# ADDENDUM No. 1

#### To JASPER MASTER LIFT STATION

October 16, 2025

# JASPER, GEORGIA

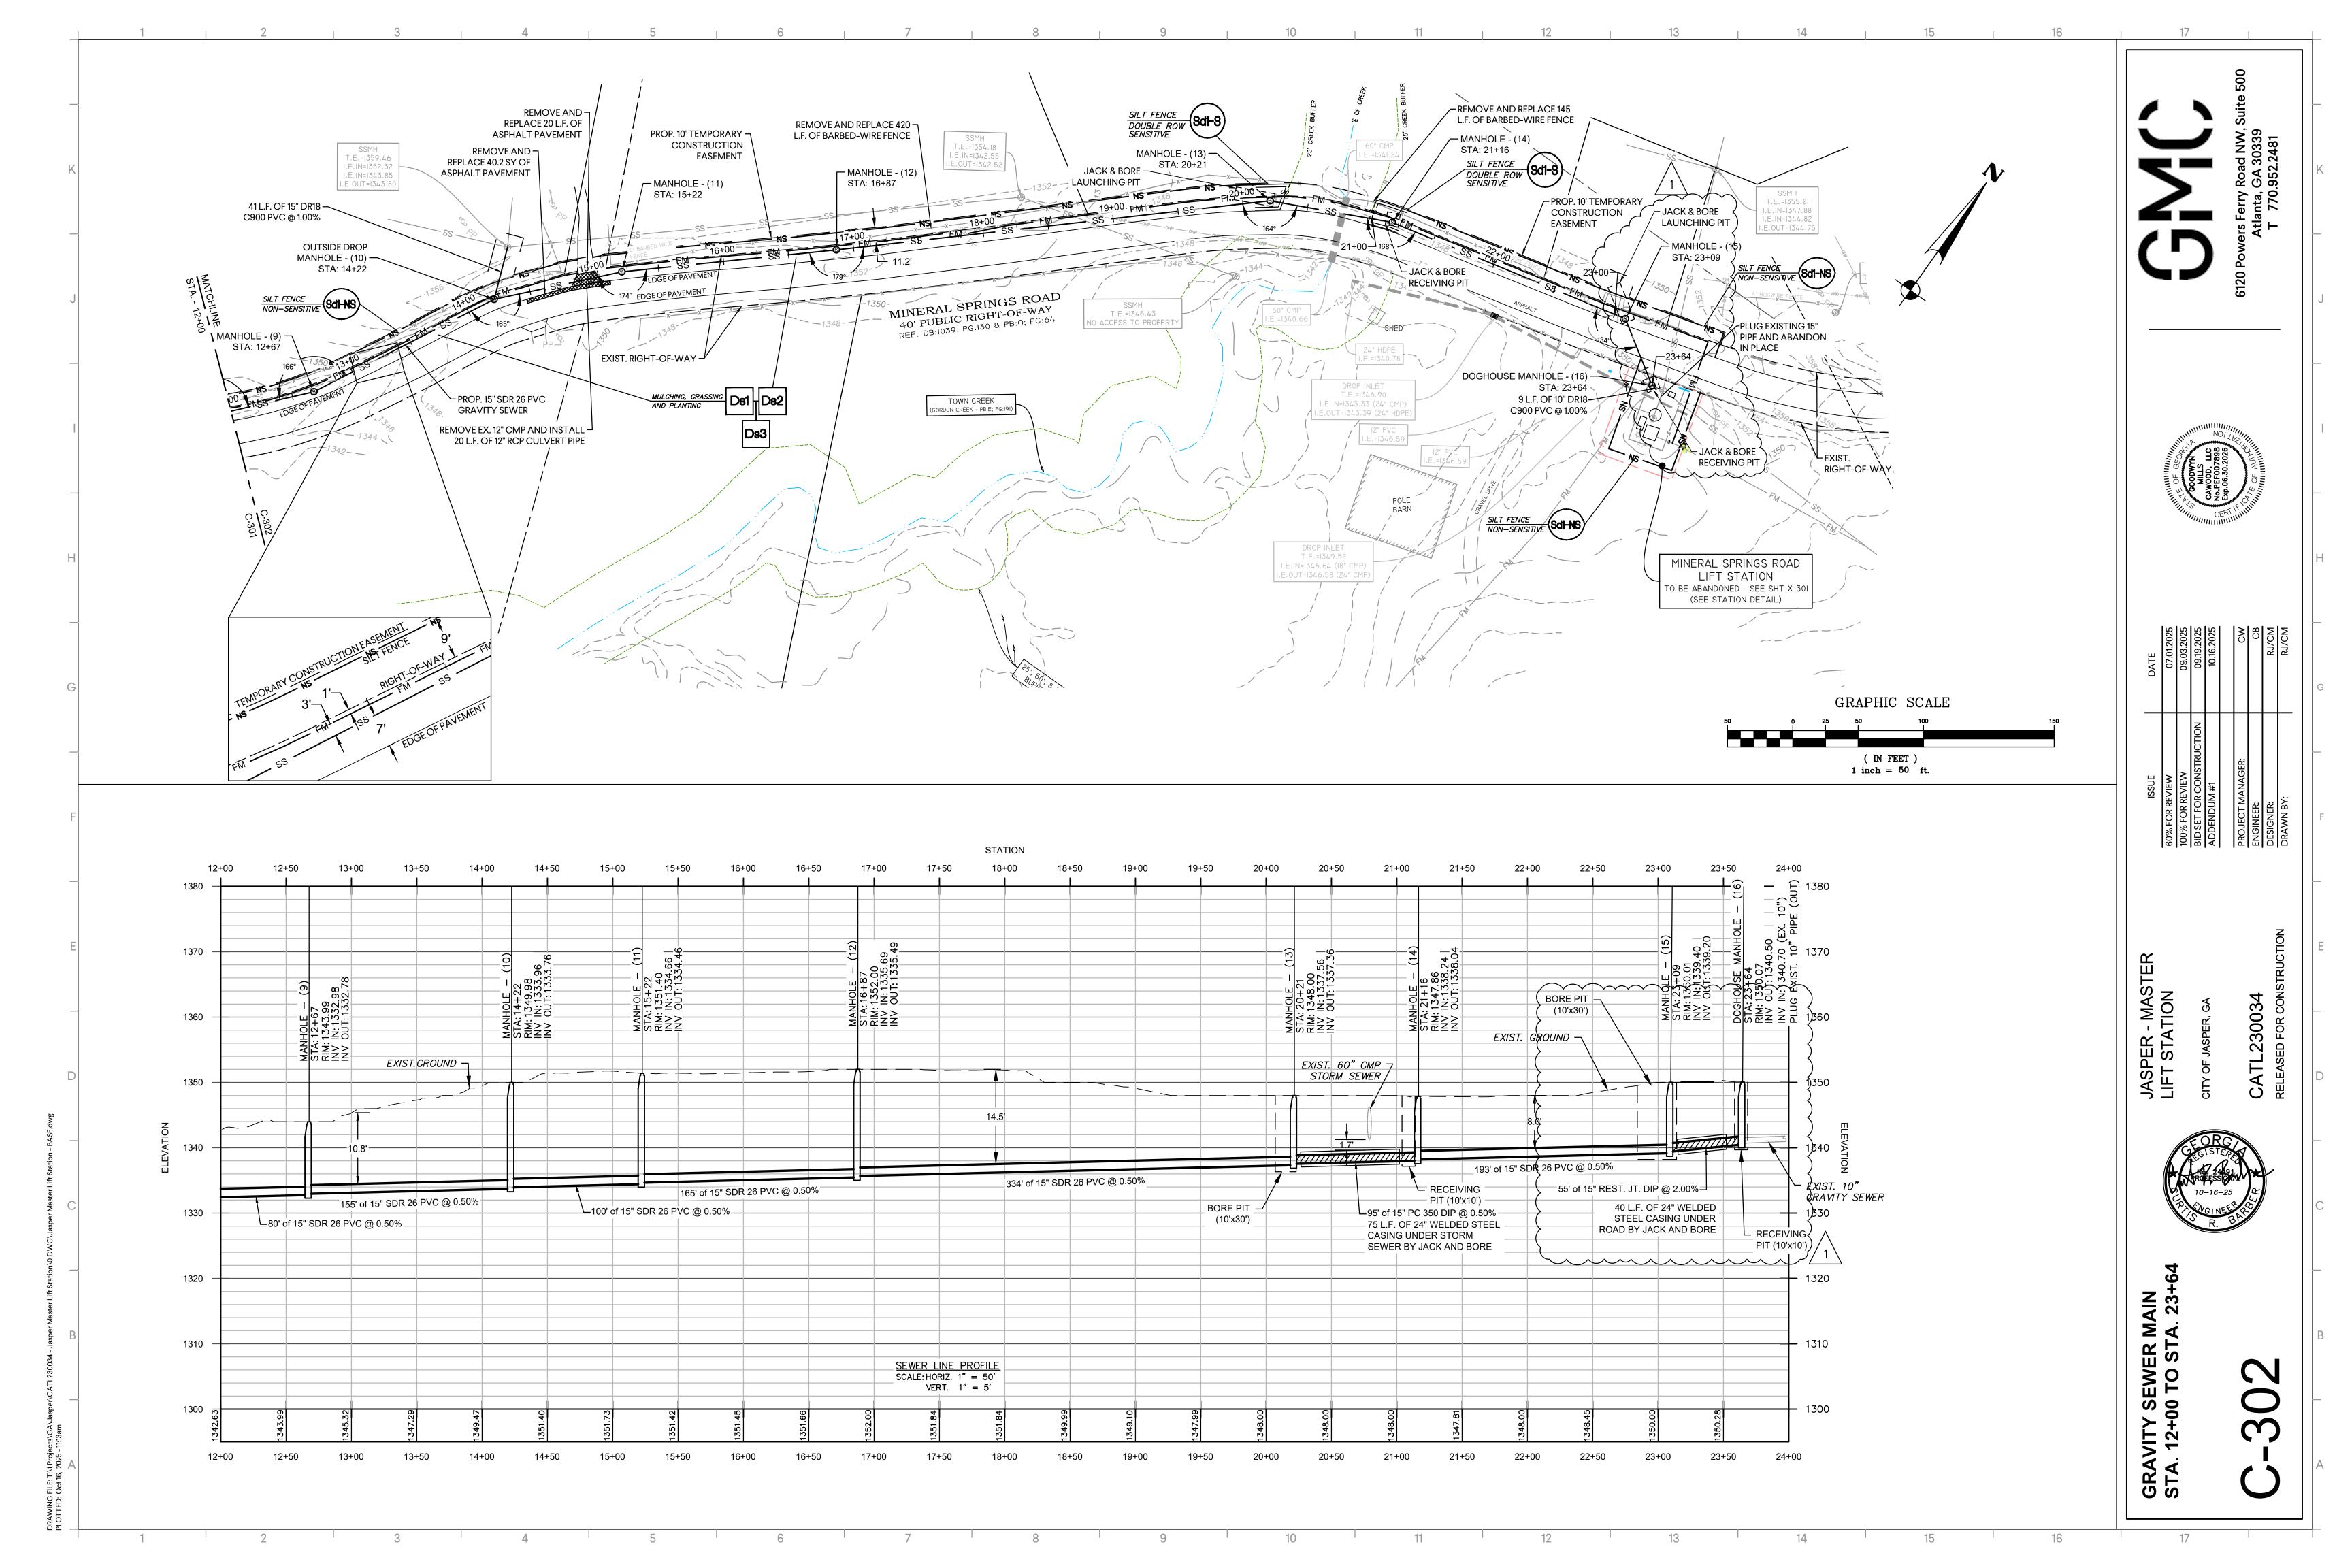
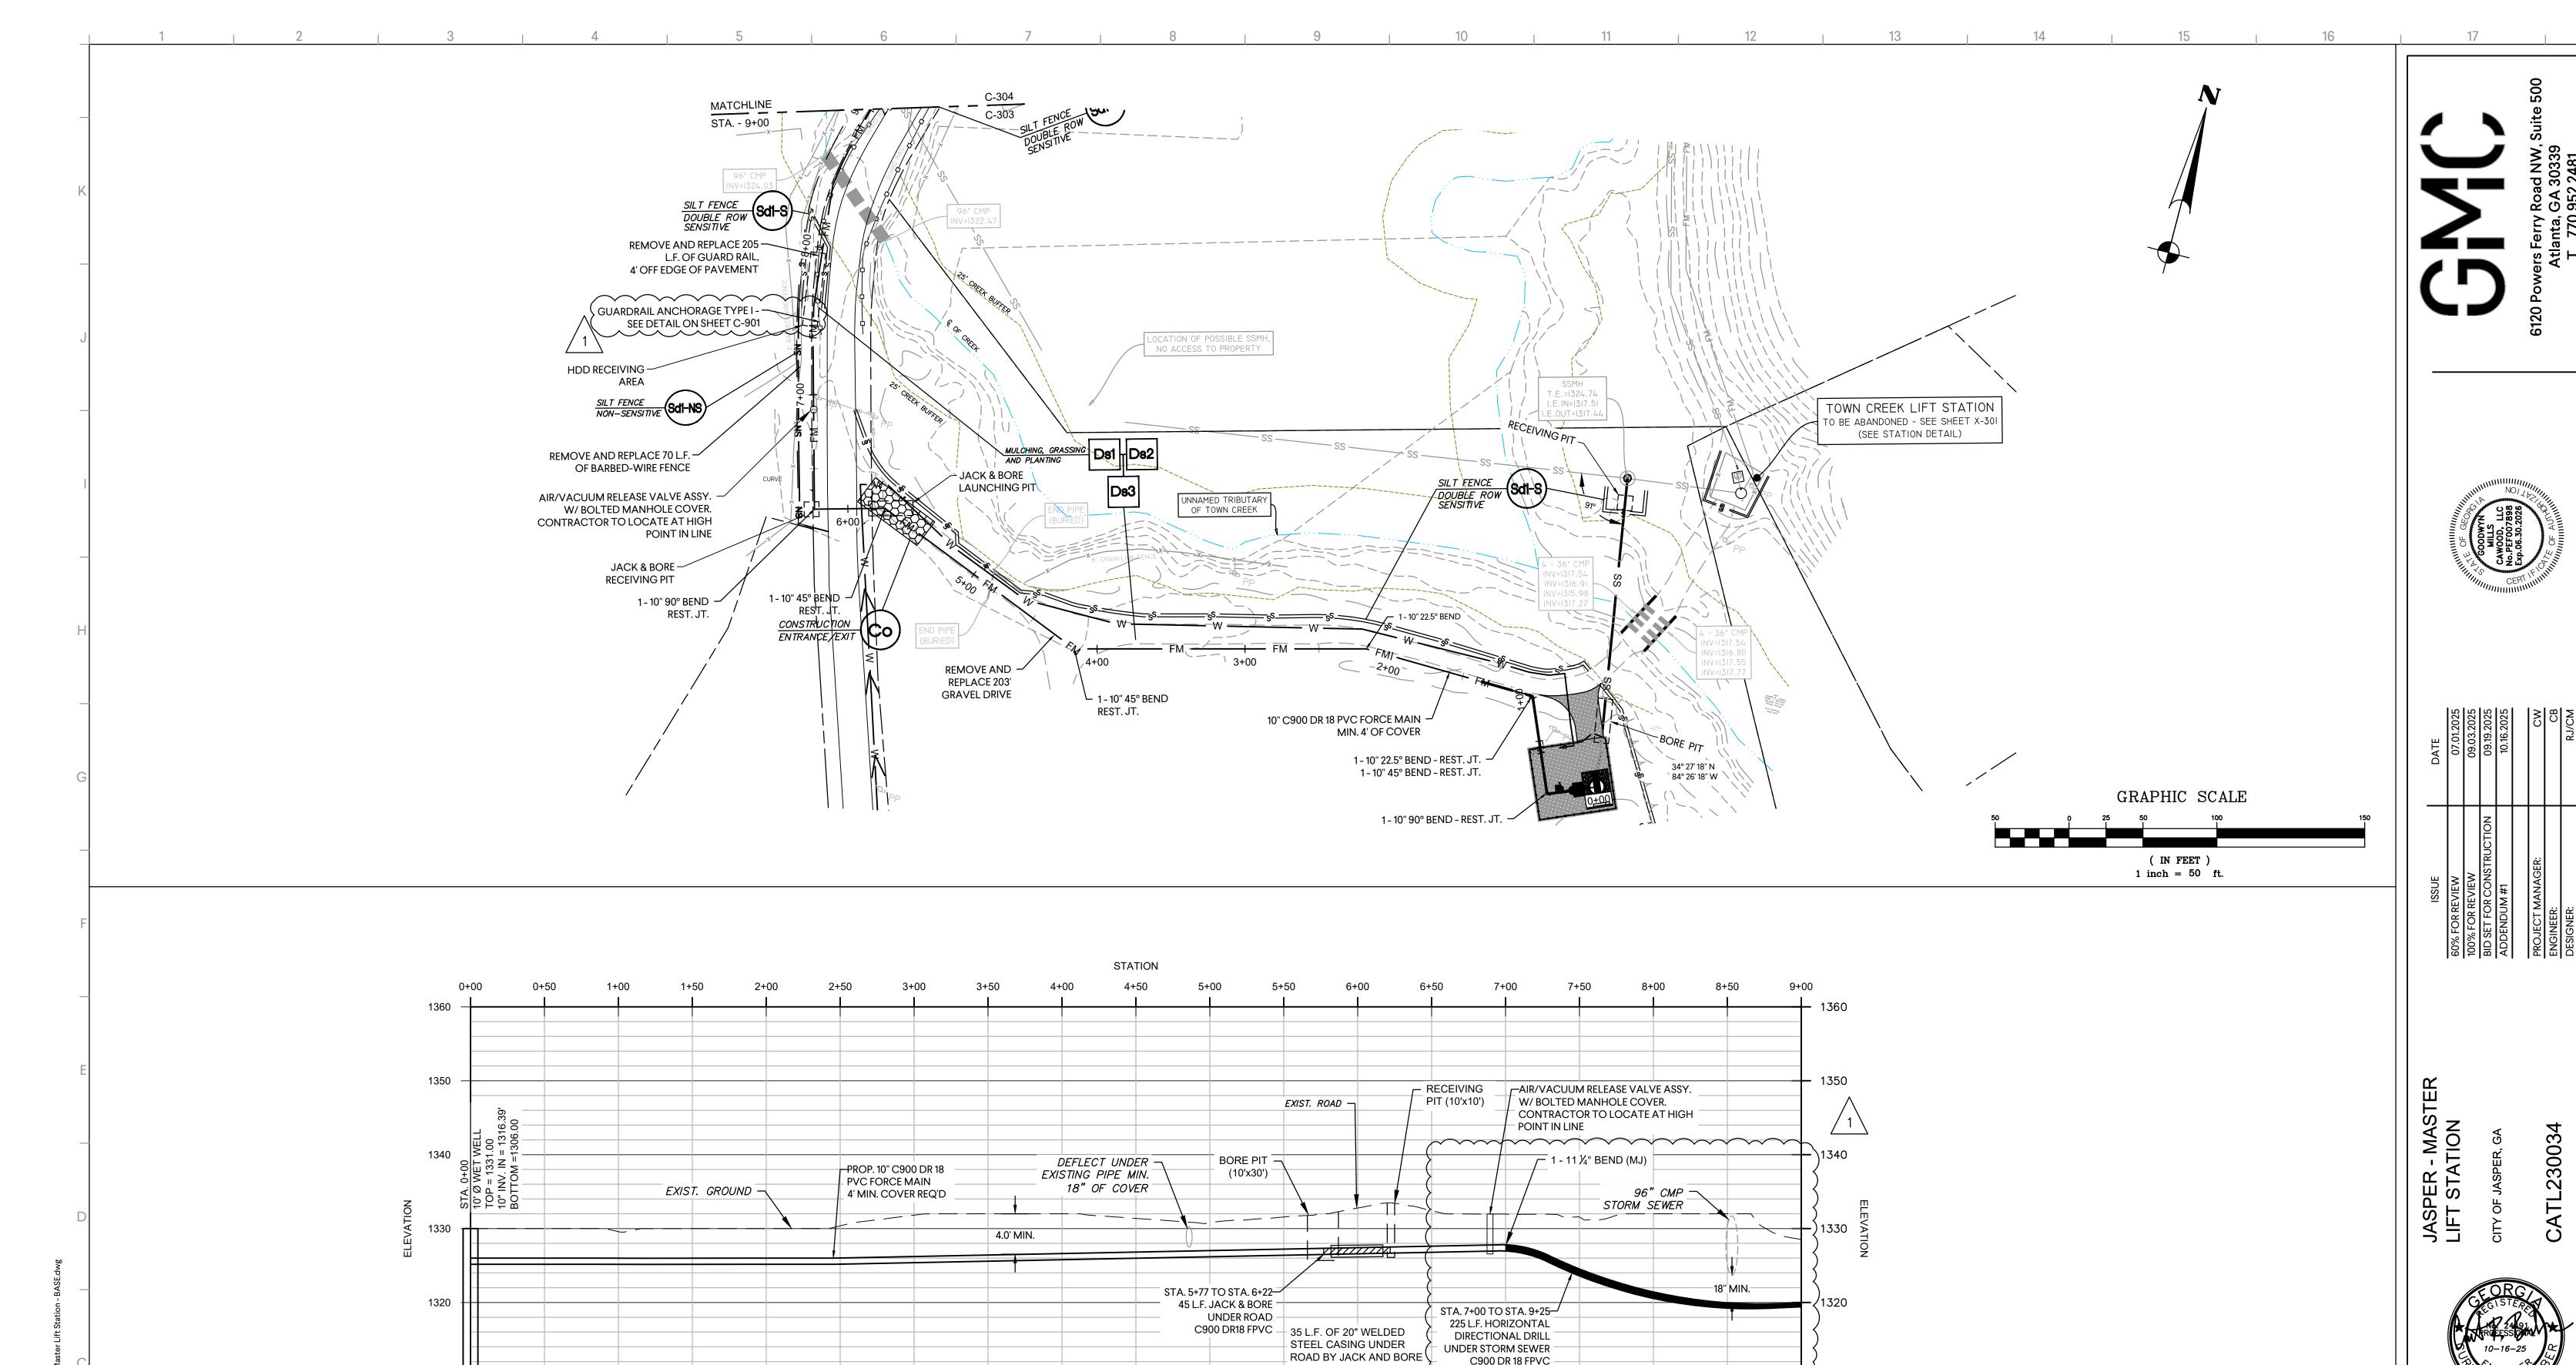
27. What Peak Surge Current do you want at each location? Is 240 kA sufficient on the Manual transfer Switch okay or do you want 300 kA?

Engineer Response: 240kA is acceptable
